Product Change Notice (PCN)

PCN Number: **PCN-0451187R-01**

Product(s) Affected: PJ-050BH

<p>PCB LAYOUT TOP VIEW</p>	 <p>Recommended PCB Layout Top View</p>

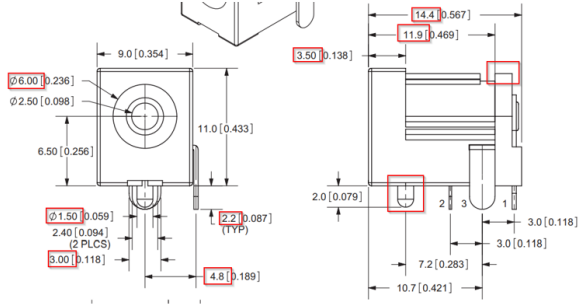
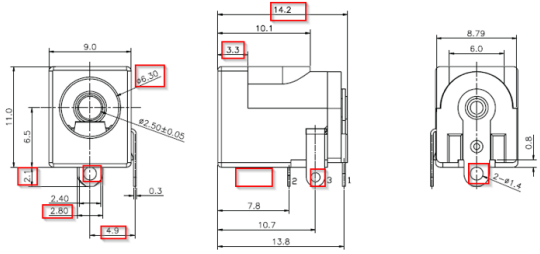
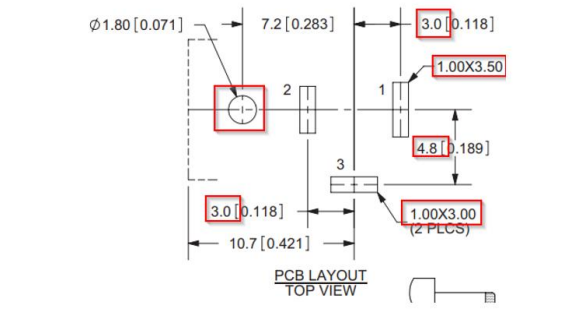
Description of Change: *Mechanical, and material changes as shown below:*

MATERIAL	PLATING
center pin	copper	nickel
terminal 1	brass	silver
terminal 2	copper alloy	silver
terminal 3	brass	silver
plastic	PBT

DESCRIPTION	MATERIAL	PLATING/COLOR
center pin	copper alloy (H65)	nickel
terminal 1	C2680 t=0.35	nickel-silver
terminal 2	C5210 t=0.25	nickel-silver
terminal 3	C2680 t=0.30	nickel-silver
cover	PA9T UL94V-0	black
housing	PA9T UL94V-0	black

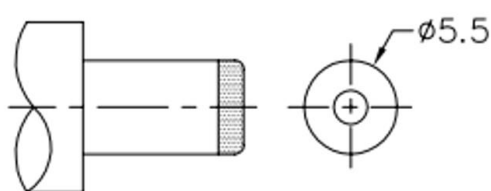
MATING PLUG
Jack Insertion Depth: 8.5 mm

MATING PLUG
Jack Insertion Depth: 9.6 mm
